21-129CP– 4012 W. DUBLIN-GRANVILLE ROAD

Summary

Construction of an approximately 14,600-square-foot, two-story, mixed-use building.

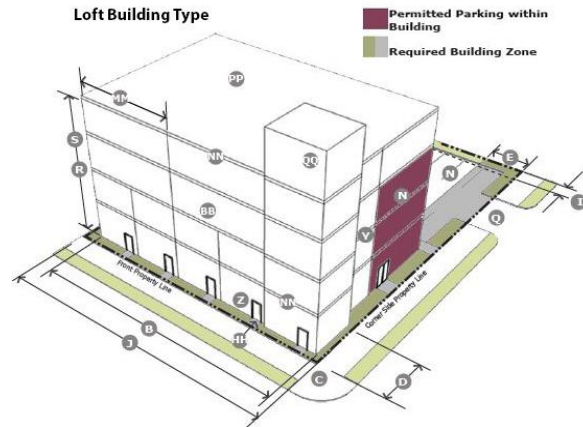
The applicant is proposing a multi-tenant building to house medical office space with a secondary leasable tenant space. The medical office use is a permitted use in the Bridge Street District, Office District. The final user for the proposed secondary leasable space is undetermined, but parking has been calculated to accommodate a restaurant user. Restaurant uses are permitted in the BSD-O district, but are limited in size to 5,000 square feet of the gross floor area, or 20 percent of the gross floor area of the ground floor of the principal structure, whichever is smaller, unless otherwise permitted as a conditional use. Should a future restaurant user desire to locate in this tenant space, the use will require review and approval of a Conditional Use application due to its proposed size, as the space is larger than 20-percent of the total ground level of the building. There are no additional use-specific standards for a medical office use in the Bridge Street District, Office District.
